WAT PRATHAT DOI SUTHEP
BUDDHIST TEMPLE OF NEW MEXICO
EPC SITE PLAN MAJOR AMENDMENT
DFT SIGN OFF

EPC MAJOR AMENDMENT DFT SIGN OFF DOCUMENT

Project # PR-2022-007851
SI-2022-02075 - Site Plan- Major Amendment

RE: PR-2022-007851, SI-2022-02075-Buddhist Temple, Site Plan – EPC Major Amendment

1 SITE PARTIAL NORTH ELEVATION
SCALE: 1/16" = 1'-0"

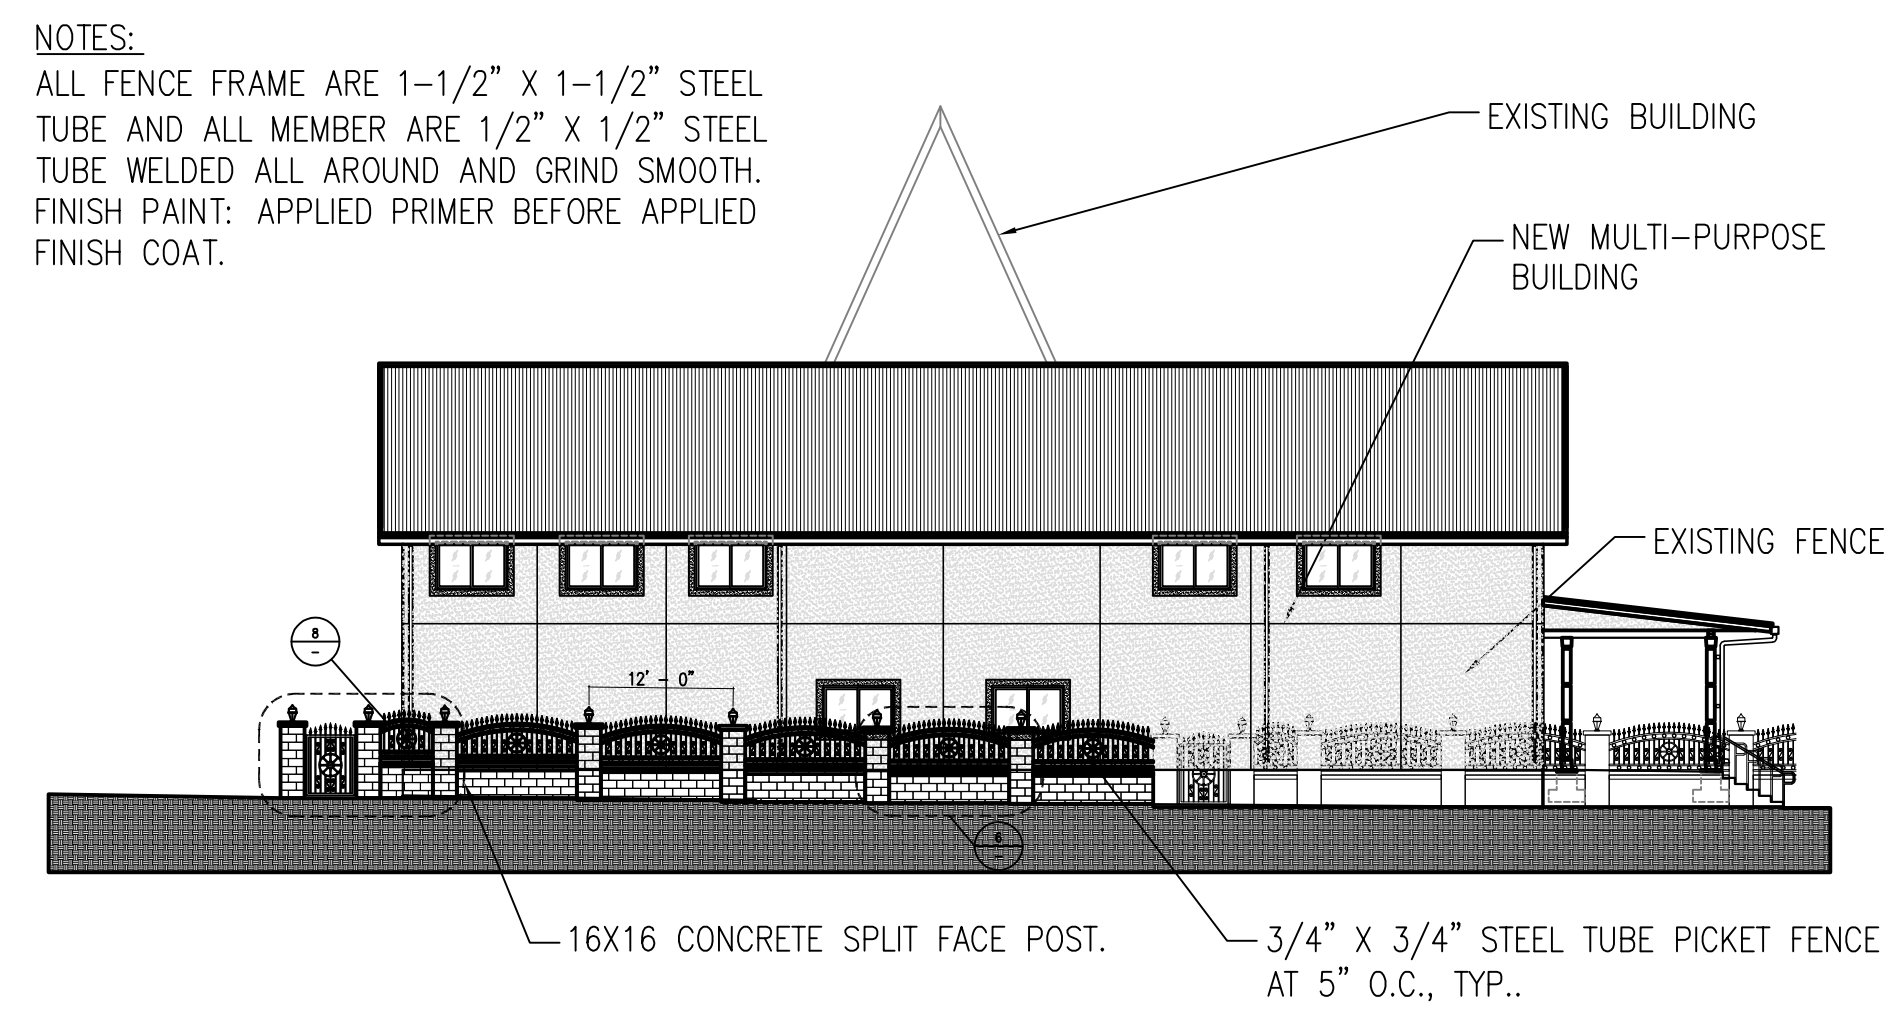
4. Site Plan: Site Plan must show all required dimensions including dimensions between light fixtures.
5. Wall/Fence height shall be subject to IDO standards unless a variance is obtained.

3. Condition has been met.
4. Condition has been met.
5. A variance for the 8-foot wall must be obtained pursuant to IDO 6-6(O) VARIANCE – ZHE. The existing wall along Zuni Rd. in the controlling Site Development Plan was constructed prior to the IDO effective date in 2018. At that time, 8-foot walls were allowed and there were no height limitations for walls in non-residential zones (see Zoning Ordinance in effect prior to 2018). If the applicant wishes to develop an 8-foot wall that matches the existing wall, a variance must be obtained to meet maximum wall height standards in IDO 5-7 before construction.

DWL Architects, Agent for Wat Prathat Doi Suthep Buddhist Temple of New Mexico, has satisfied Conditions for NOD dated December 15, 2022 (PR-2022-007851, SI-2022-02075) Site Plan EPC, Major Amendment. A variance for the proposed wall along Louisiana Blvd. must be obtained before construction.

SHEET TITLE:
TRASH ENCLOSURE
PLAN AND DETAILS

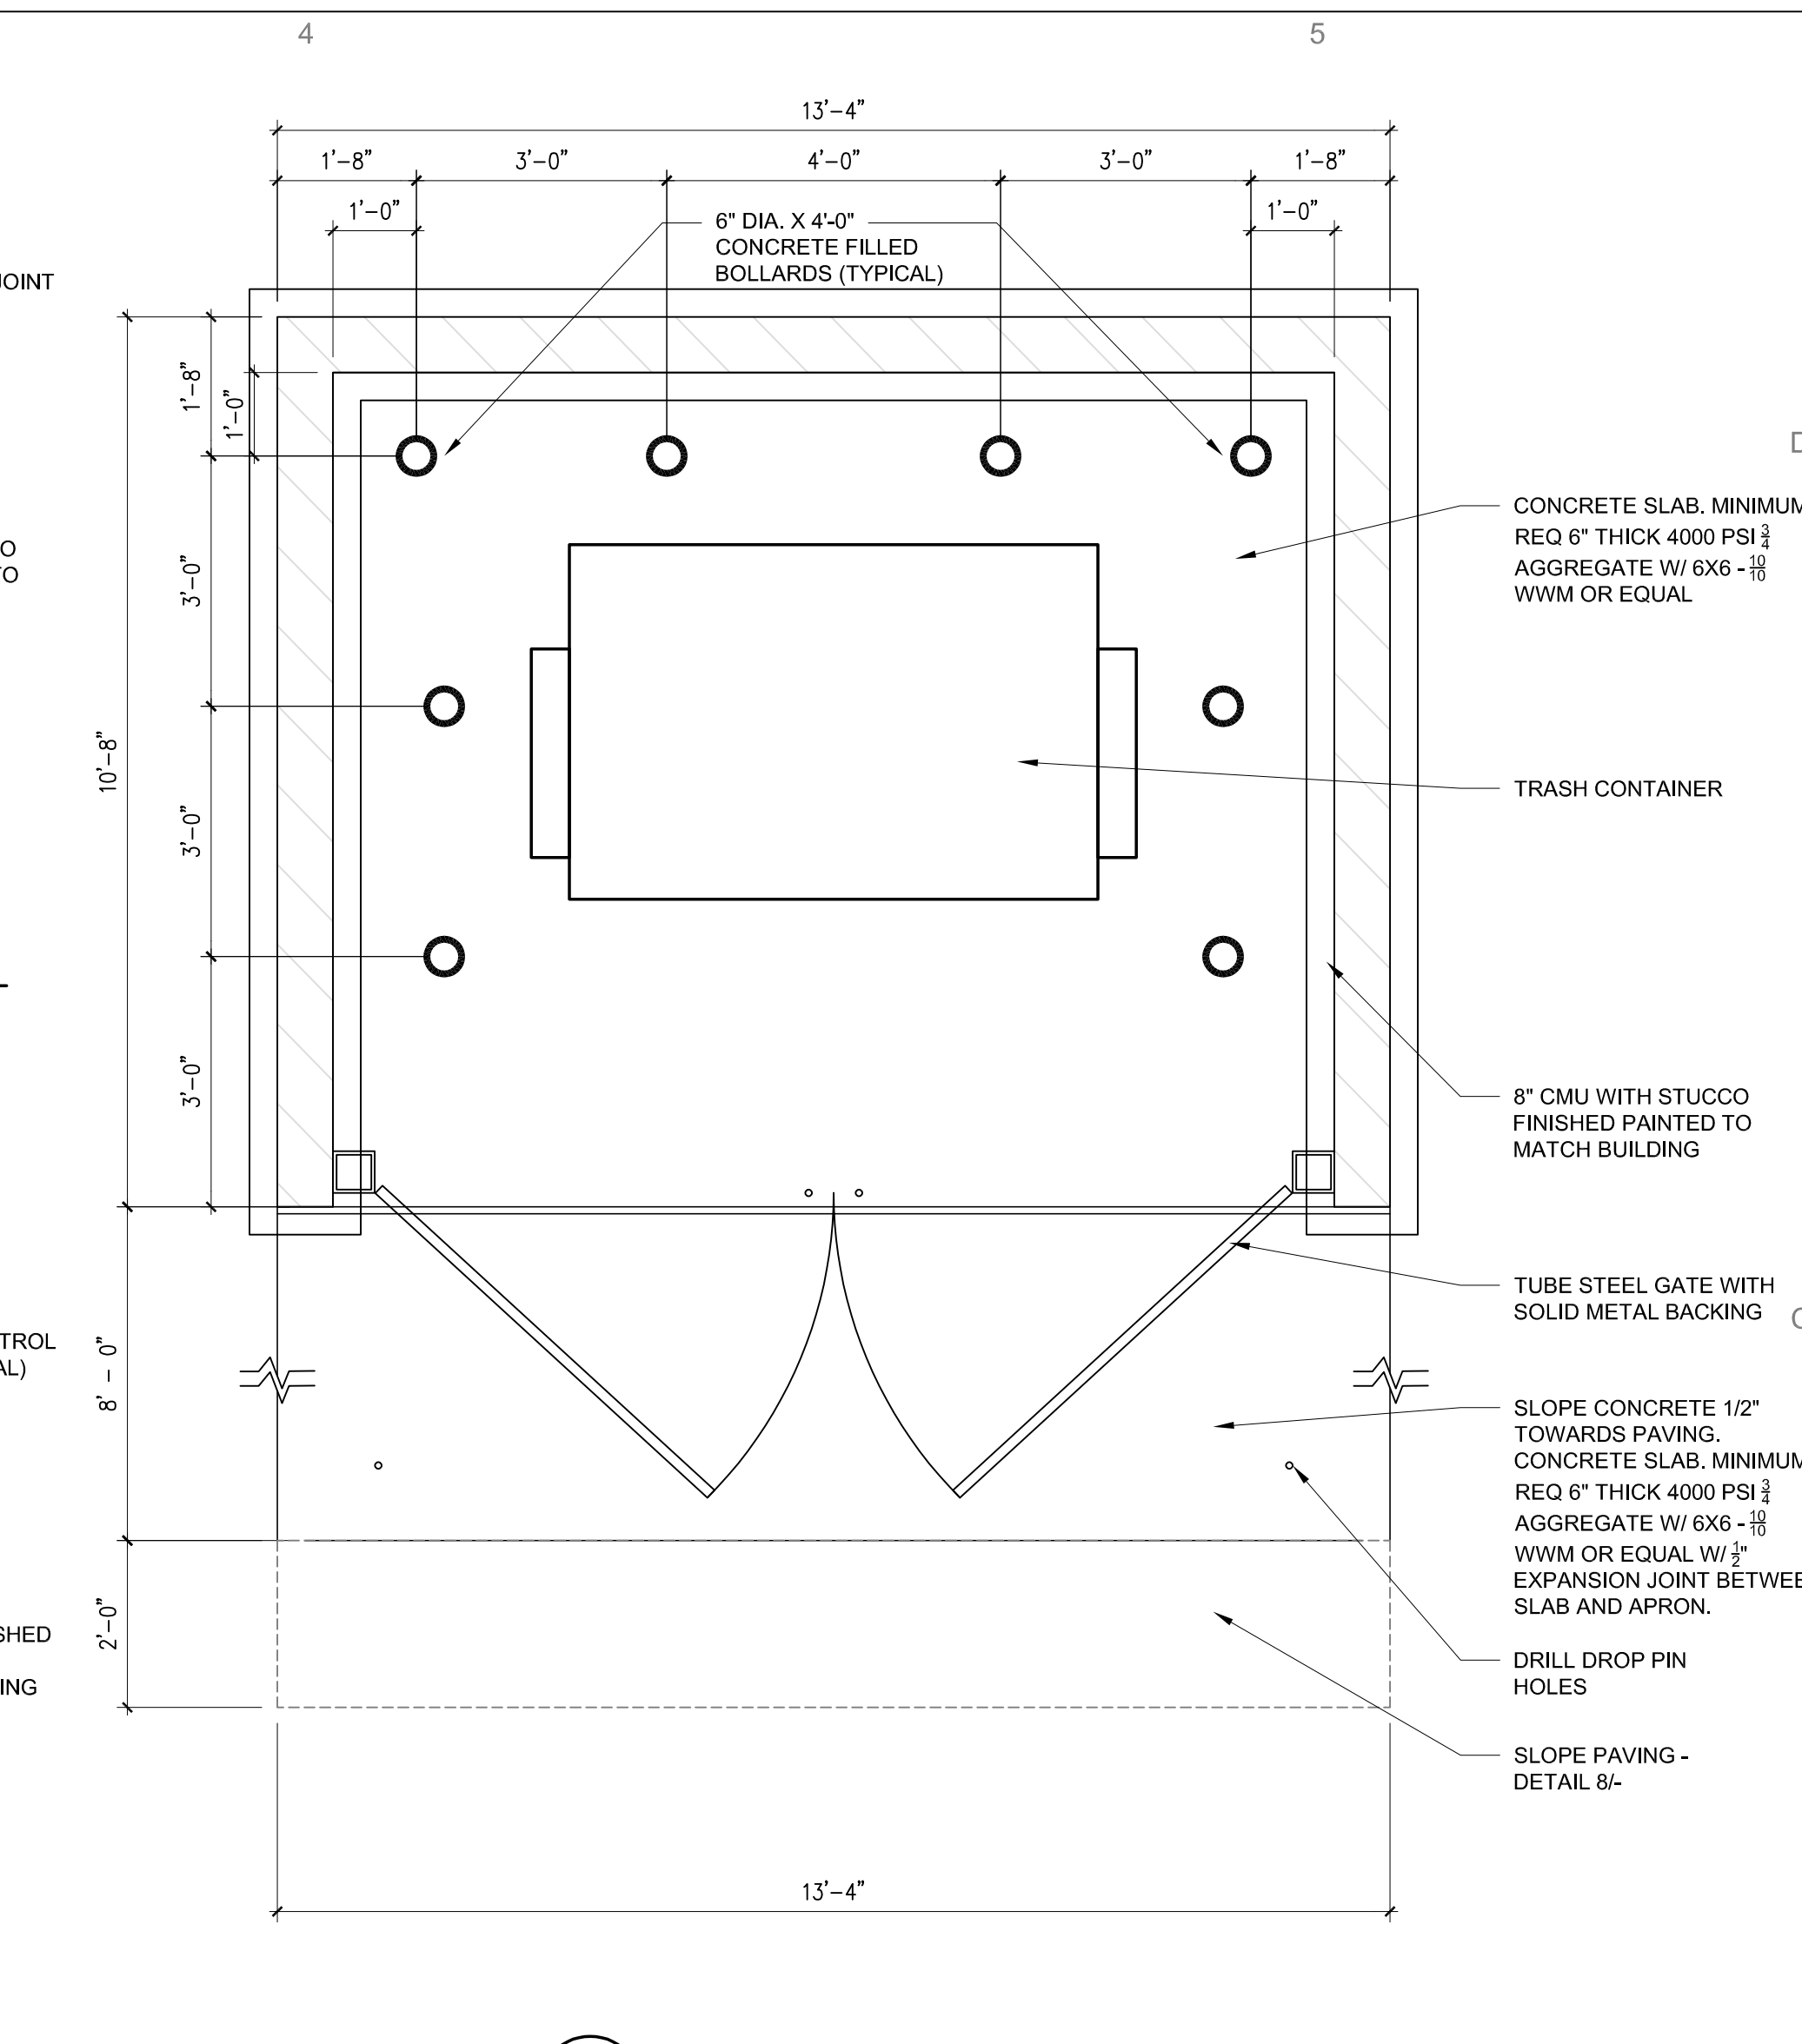
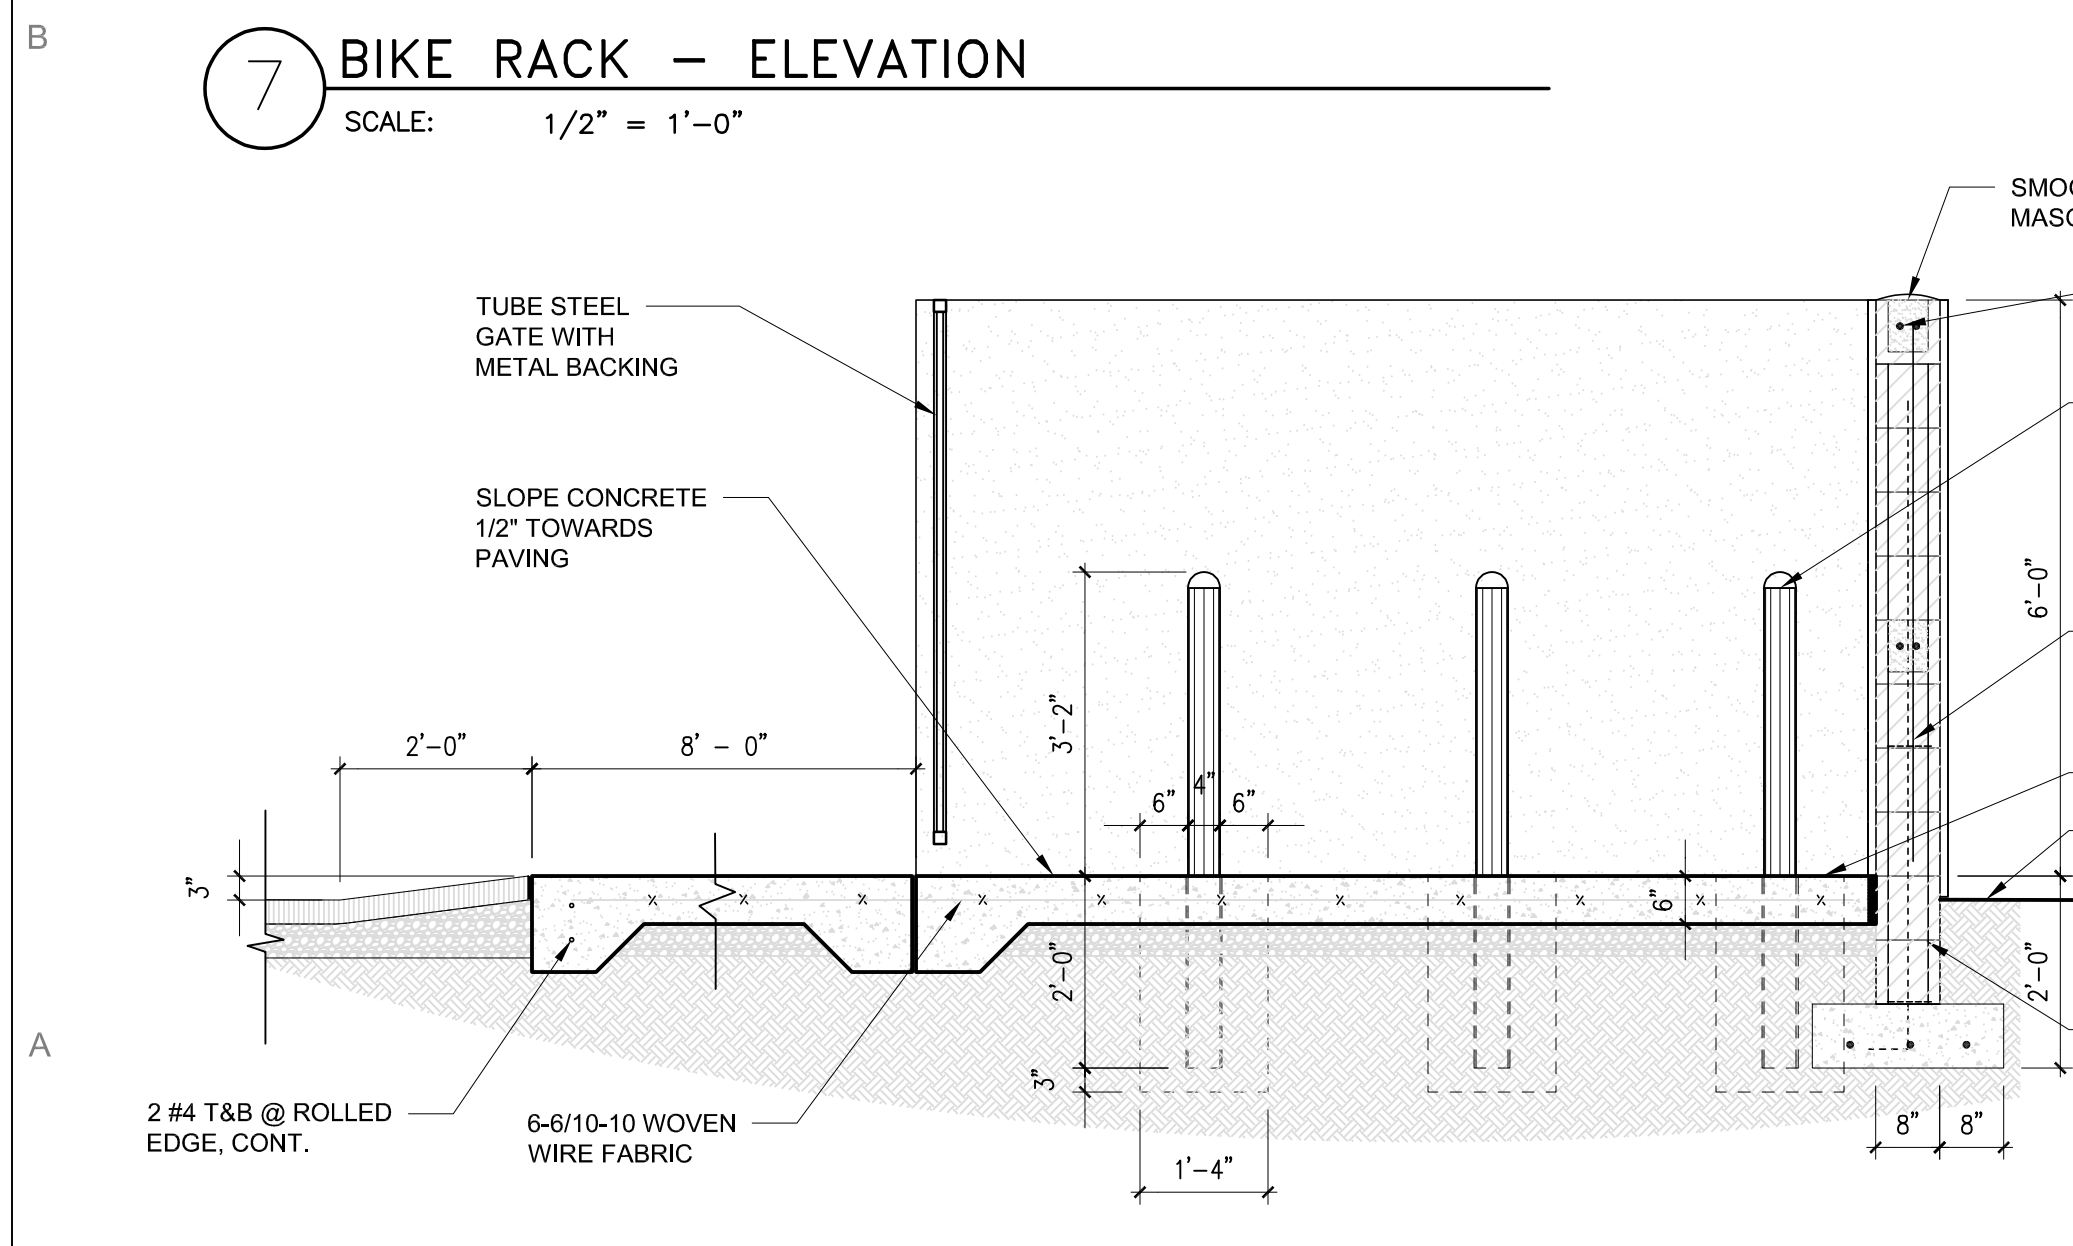
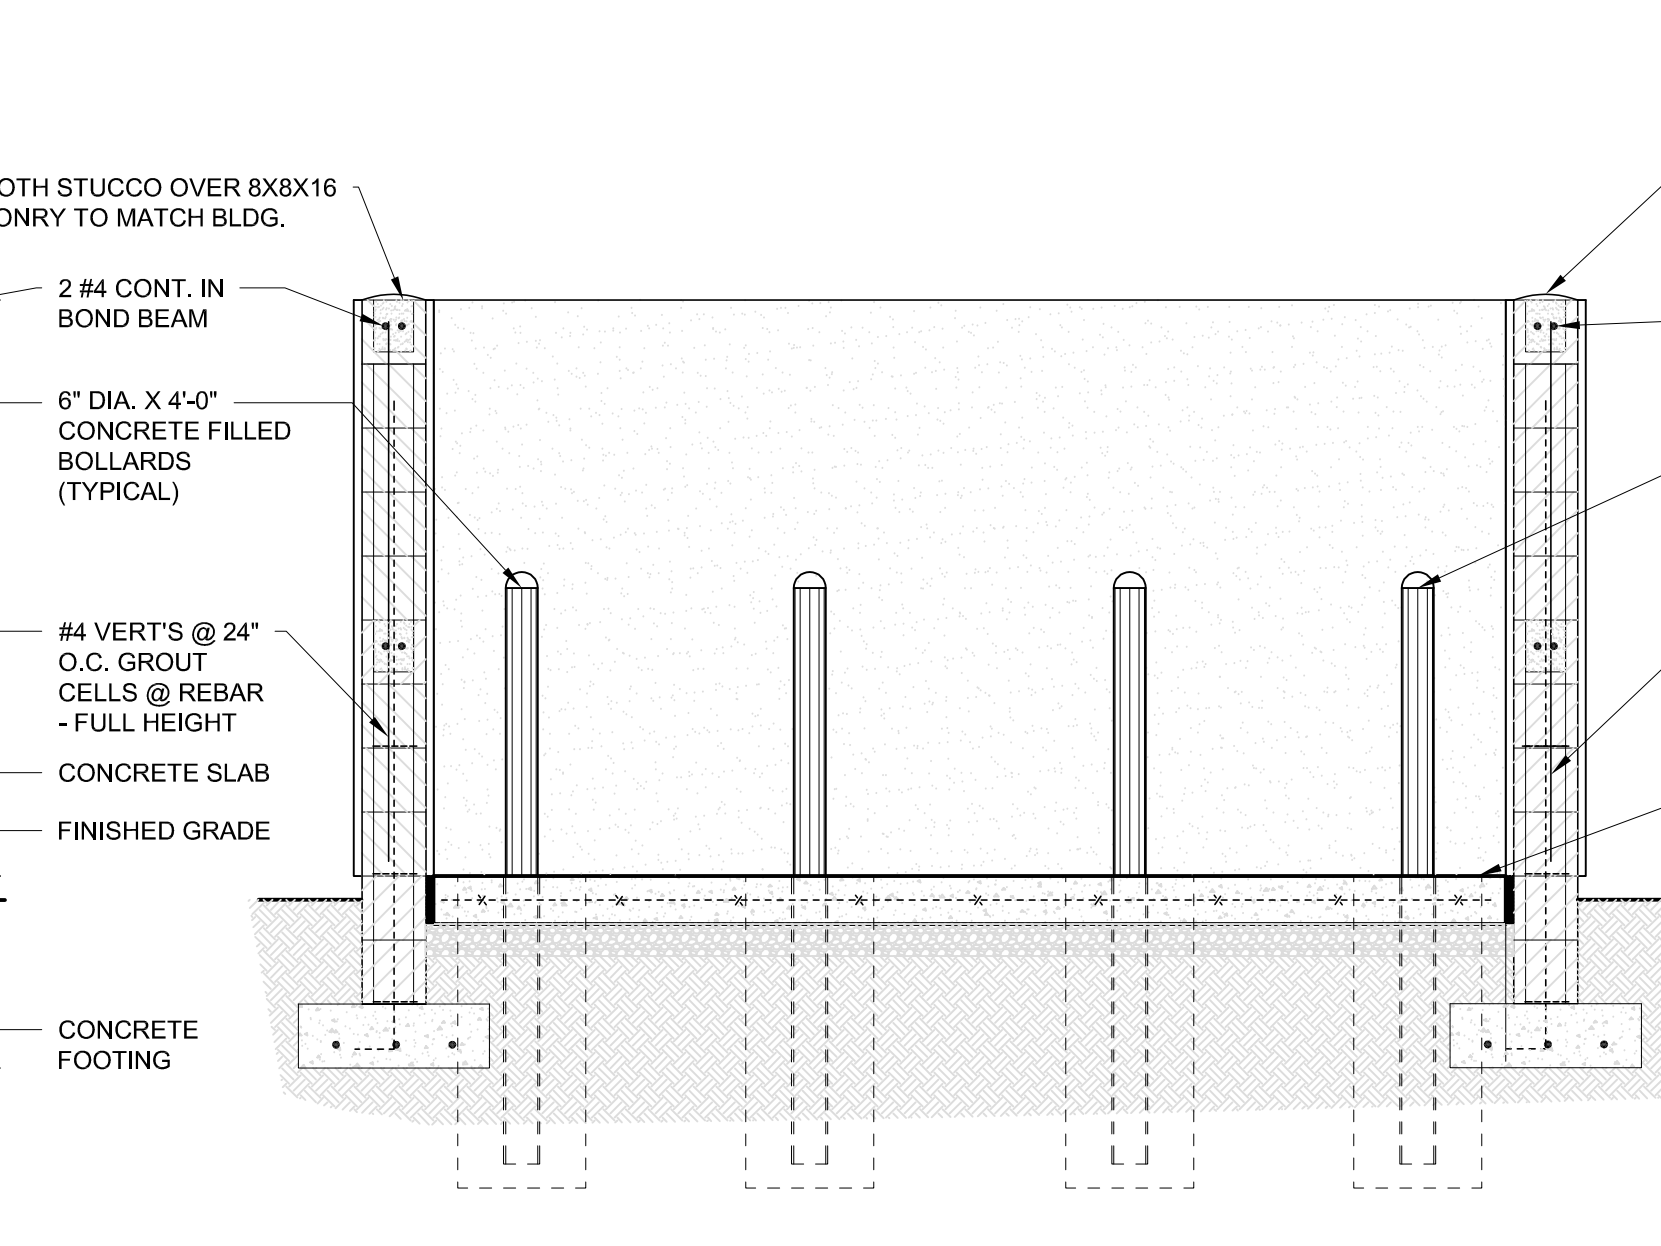
6. Elevations shall specify building materials and colors.
7. CONDITIONS FROM THE SOLID WASTE MANAGEMENT DEPARTMENT
 - A. A site plan approved for access signed by the Solid Waste Department will be required.

The trash enclosure design on sheet A1.3 Plan & Details reflect the SWMD dimensions and construction materials requirements of the "enclosure specifications" document. This enclosure does not require an exterior sanitary sewer drain, this facility is not a "Restaurant, Food Services or Food Distributors" function.
